Homestake Mining Company of California

**RE: Responses to NMED Comments received 25 June, 2014 regarding the 21 November 2013  
submittal entitled, "Update on treatment activities at Homestake"**

## **Grants Reclamation Project**

### **Responses to NMED Comments Regarding Homestake's November 2013 "*Update on Treatment Activities*"**

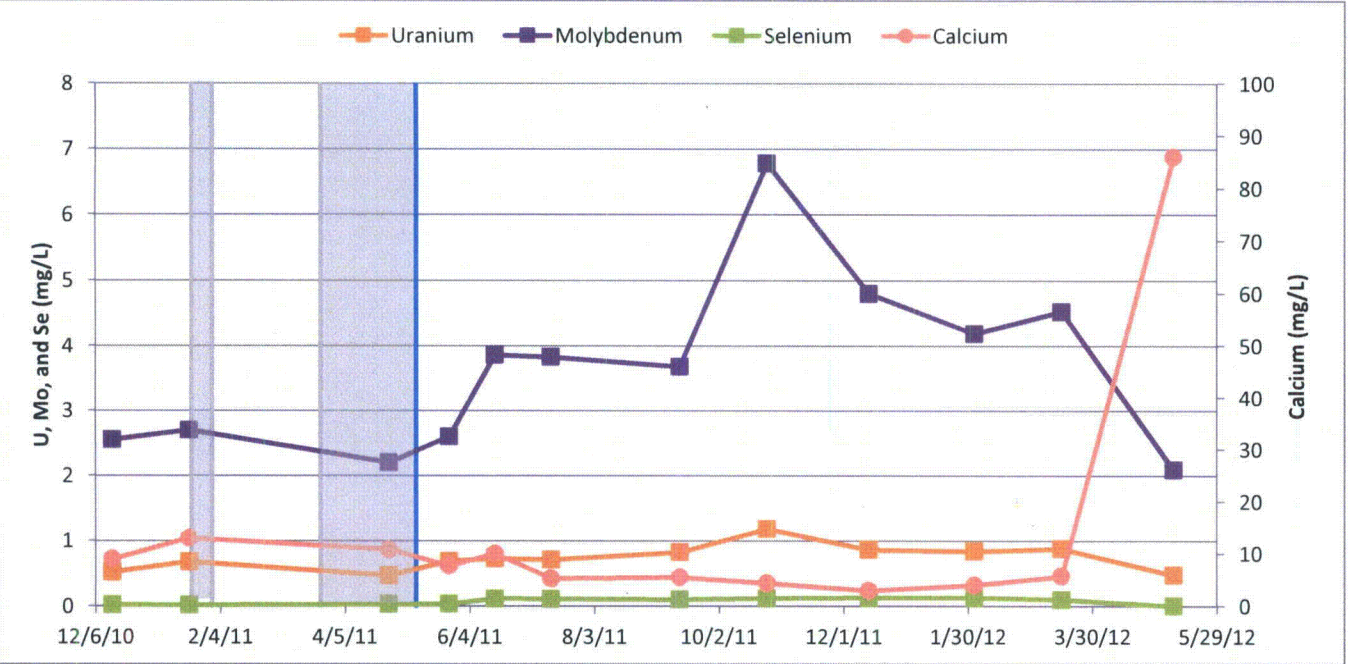
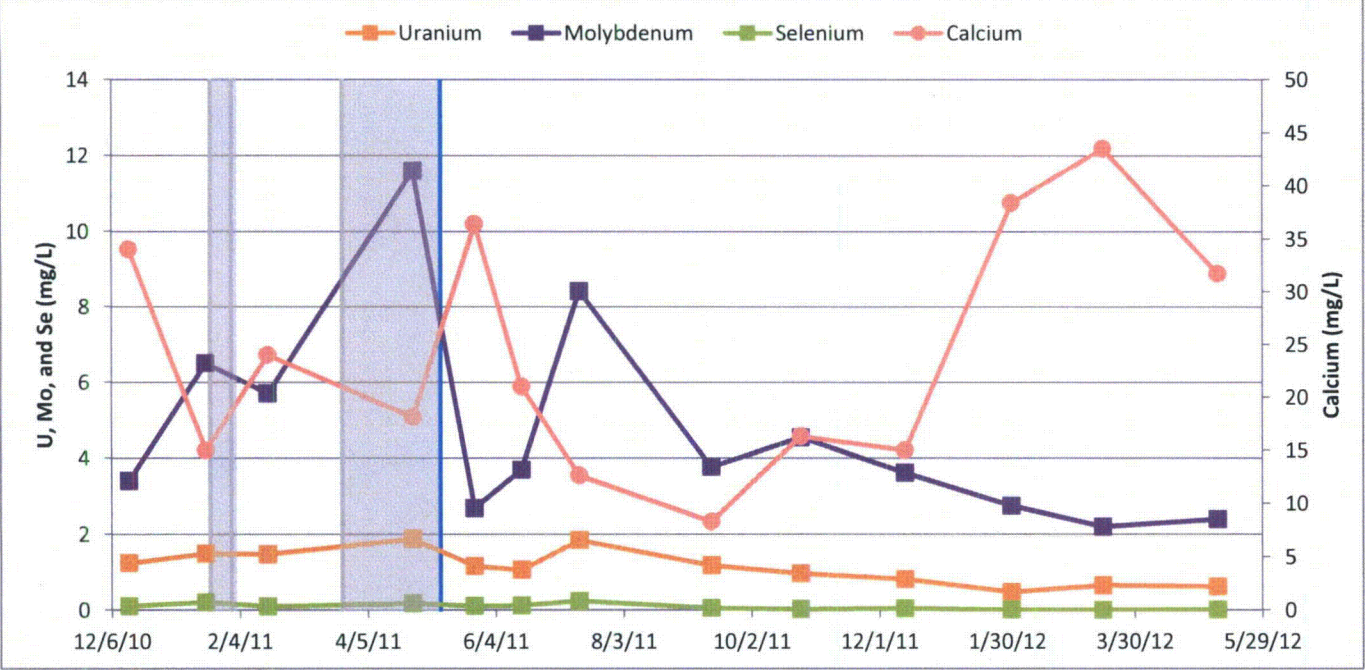
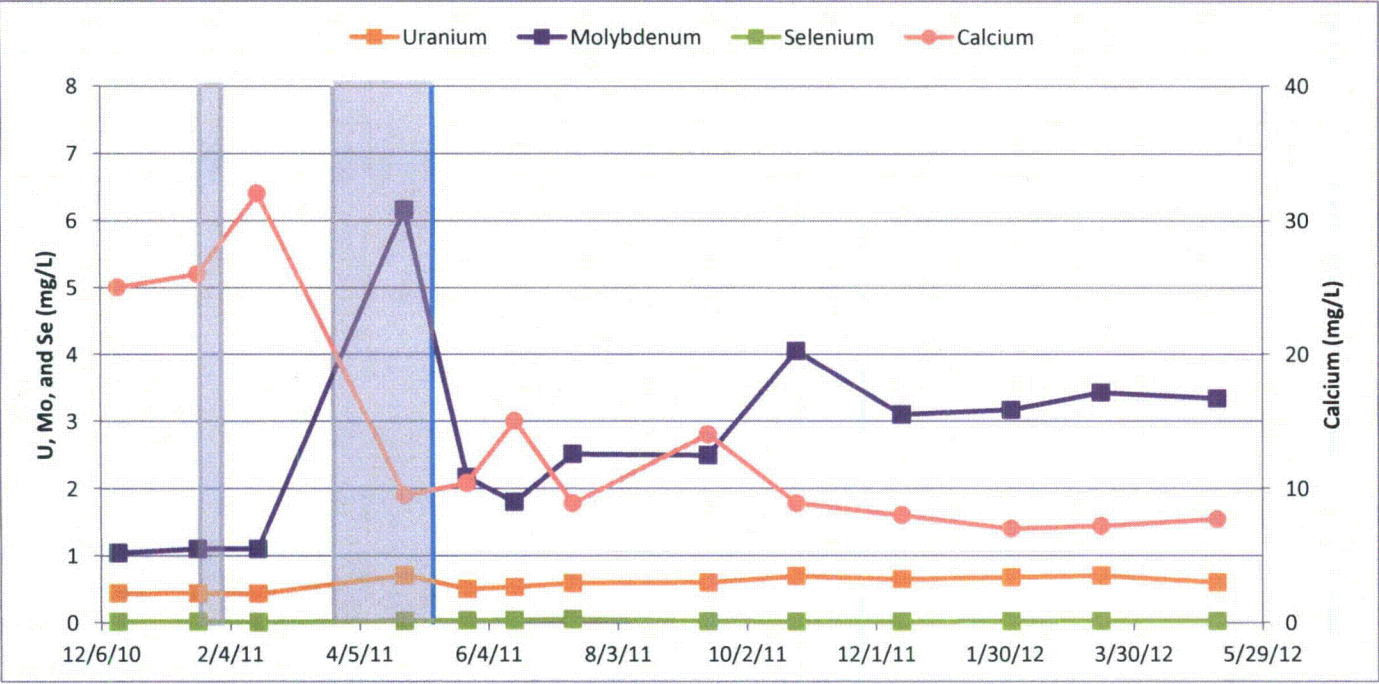
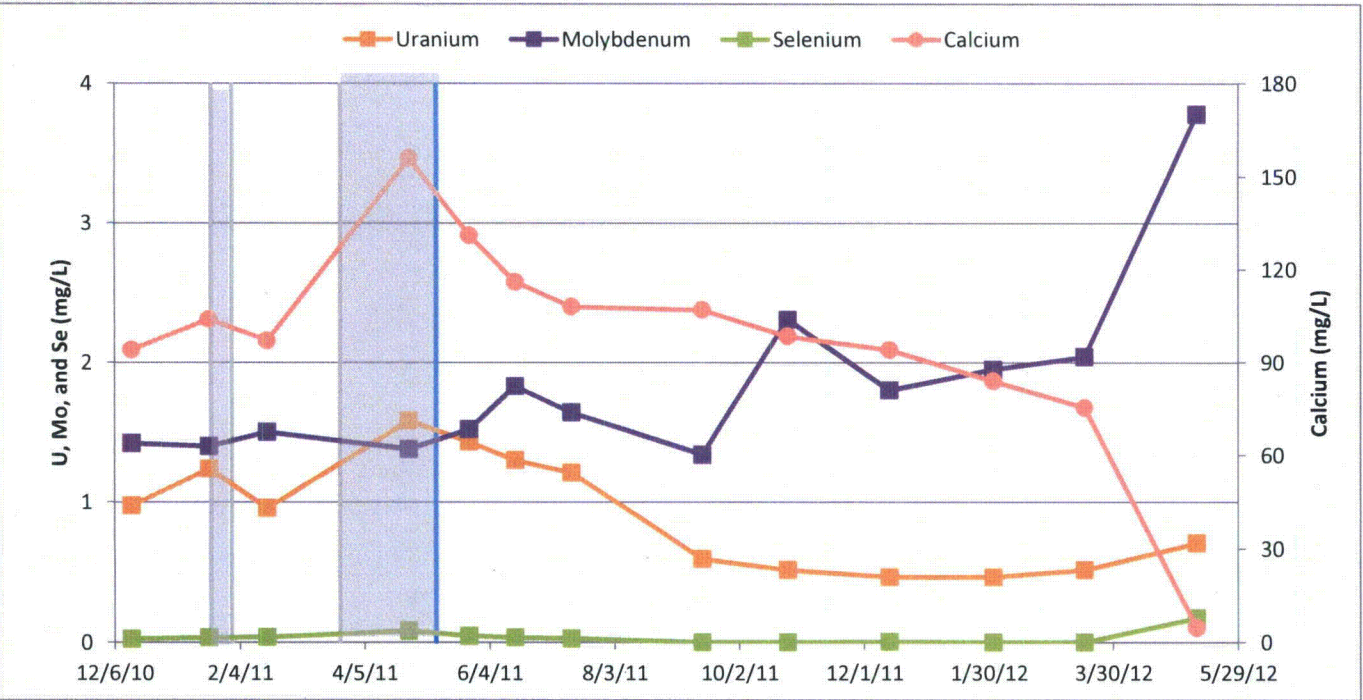
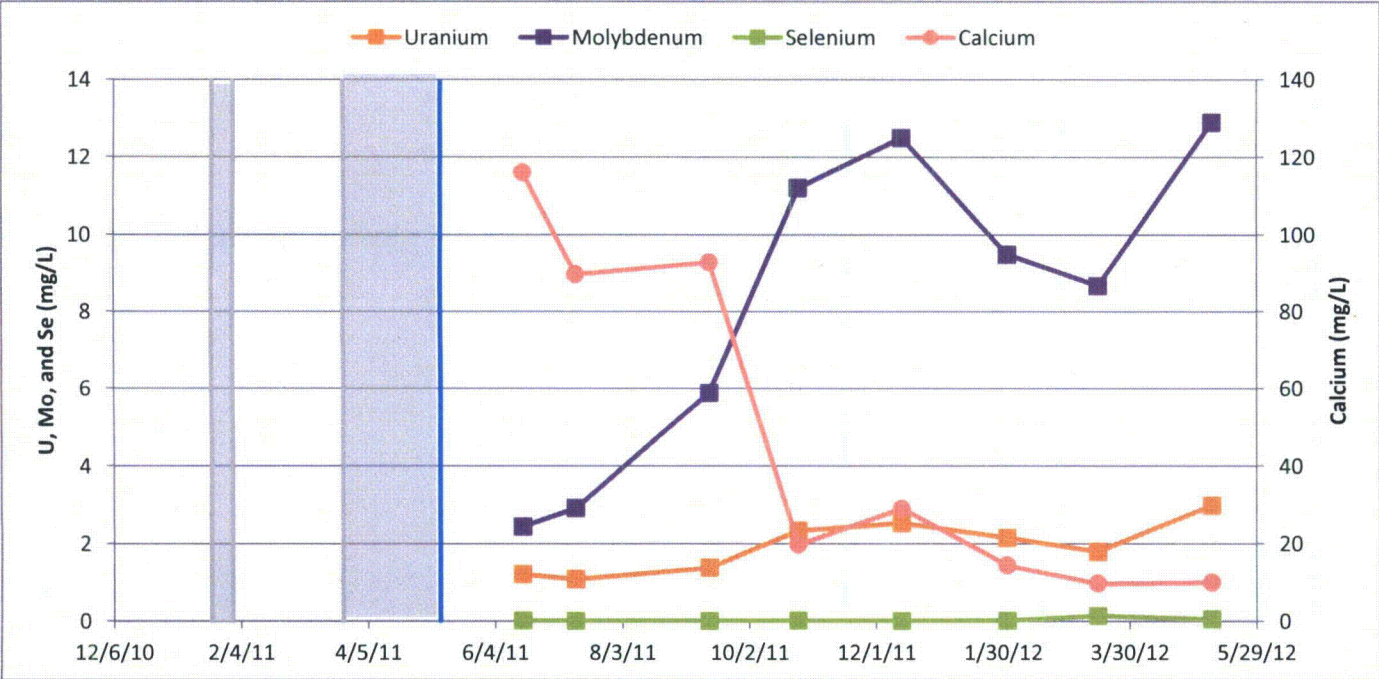
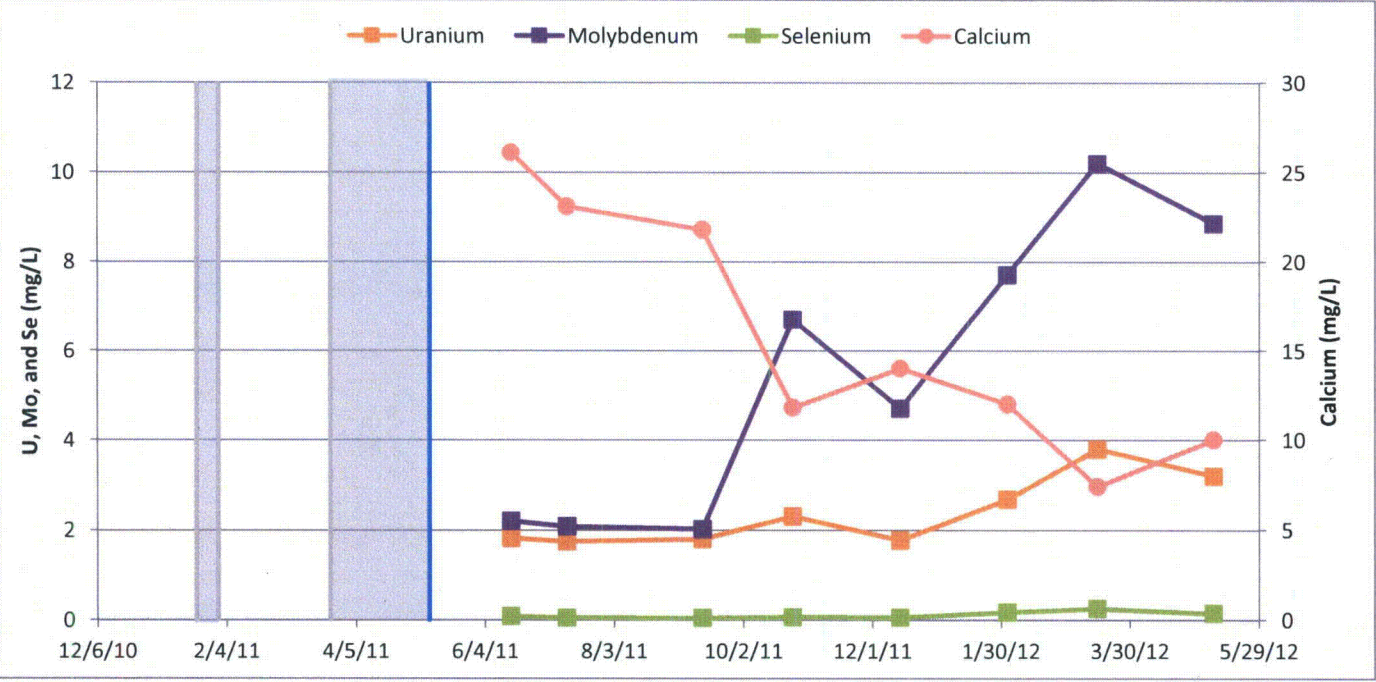
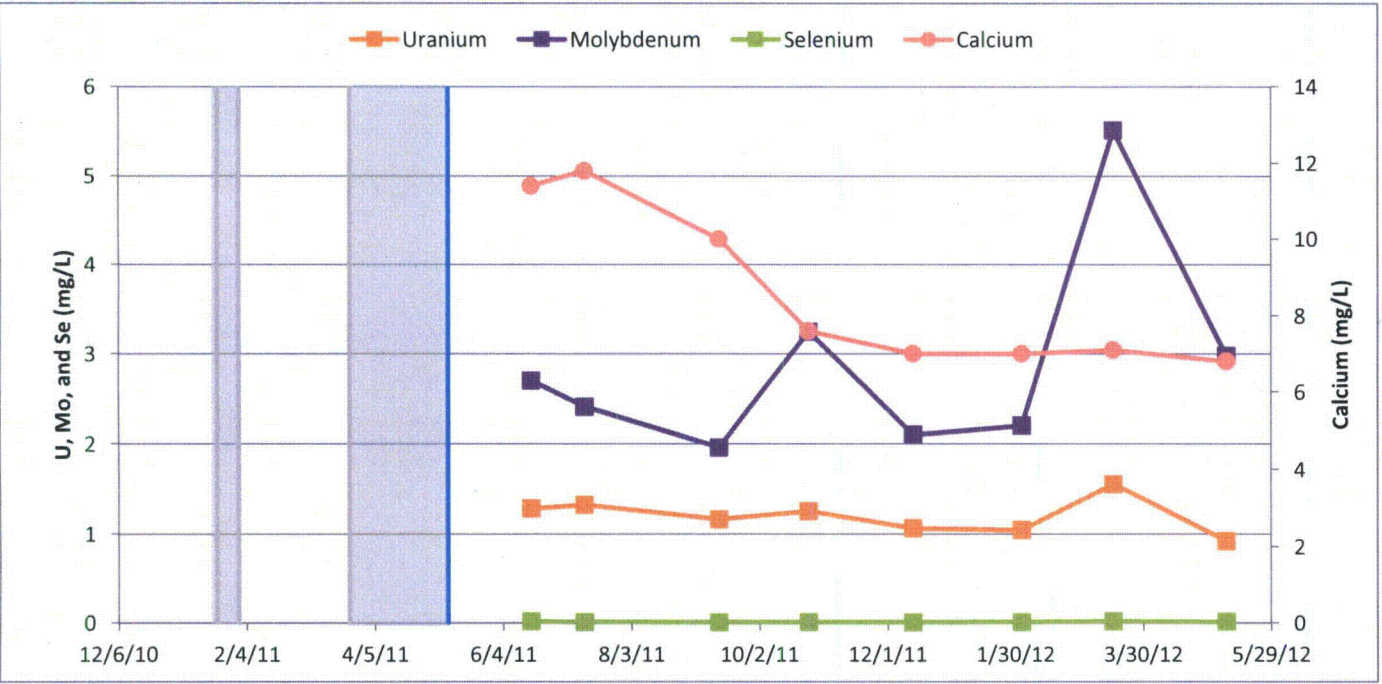
17	Rebound Evaluation Summary Report	The charts labeled “COCs + calcium” on the “At-a-glance” charts that comprise Attachment A each include time-series concentration plots for four analytes; however only the calcium line is labeled. Please submit corrected figures with appropriate labeling.	Revised “At-a-glance” are included as an Attachment 3.
